# Access Compliance Report

## Public Rights-of-Way (Curb Ramps)

Intersection ID: N/A	Main Street: ARBOR_LOOP_DR	Cross Street: POTOMAC_RIVER_PY	Location: NW
ADA ID: FBBE630659C4	Ramp Type: Directional2	Initial Pass/Fail: Fail	Overall Compliance: No
		Severity Score: 1.25

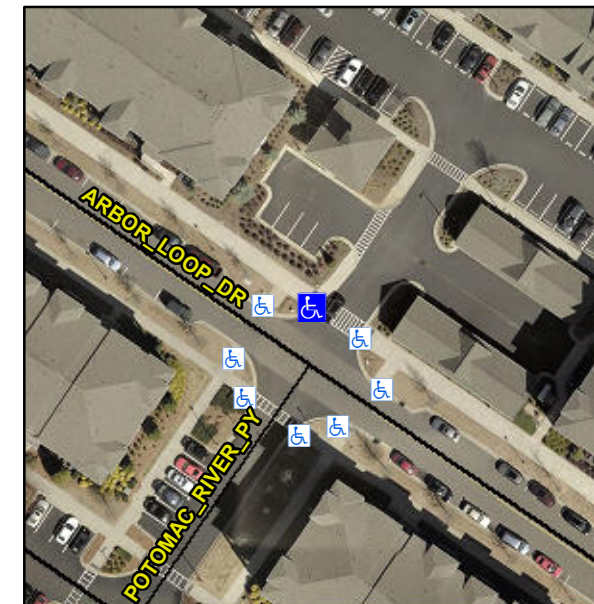
**R304.5.3**

Compliance	Description	Data	Compliance	Description	Data
N/A	Ramp Length (in)	78.0	N/A	Grade Break?	N/A
Yes	Ramp Width (in)	117.0	N/A	Grade Break Slope (%)	0.0
Yes	Ramp Slope (%)	0.7	N/A	Grade Break XSlope (%)	0.0
No	Ramp XSlope (%)	2.7			
N/A	Flare Type LT	N/A	N/A	Flare Type RT	N/A
N/A	Flare Slope LT (%)	N/A	N/A	Flare Slope RT (%)	0.0
N/A	Flare Traversable LT?	N/A	N/A	Flare Traversable RT?	N/A
N/A	Landing Length (in)	0.0	N/A	DWS Provided?	N/A
N/A	Landing Width (in)	0.0	N/A	DWS Contrast?	N/A
N/A	Landing Slope (%)	0.0	N/A	DWS Length (in)	N/A
N/A	Landing X Slope (%)	0.0	N/A	DWS Full Width?	N/A
N/A	Landing Curb? (Y/N)	N/A	N/A	DWS Offset LT (in)	N/A
N/A	Shared Landing?	N/A	N/A	DWS Offset RT (in)	N/A
N/A	Gutter Ponding?	0.0	N/A	Gutter Slope (%)	N/A
N/A	Gutter Lip Ht (in)	0.0	N/A	Gutter X Slope (%)	N/A
N/A	Painted X Walk1?	Yes		Road Slope (%)	0.9
	X Walk 1 Direction	To E		Road X Slope (%)	3.0
	X Walk 1 Width (in)	118.0		Clear Space?	N/A

X Walk 1 Slope (%)	0.9	N/A	Clear Space to XWalk (in)	N/A
	X Walk 1 X Slope (%)	3.0	N/A	Storm Grate/Utility Hazard?	N/A
N/A	Ramp inside XWalk1?	Yes		Storm Grate/Utility Type	
N/A	Any Obstructions?	N/A			N/A
	Obstruction Type		Yes	Surface Condition? (G/P)	Good
			N/A	Curb Slope (%)	0.6

**Remove & Replace Entire Ramp.**
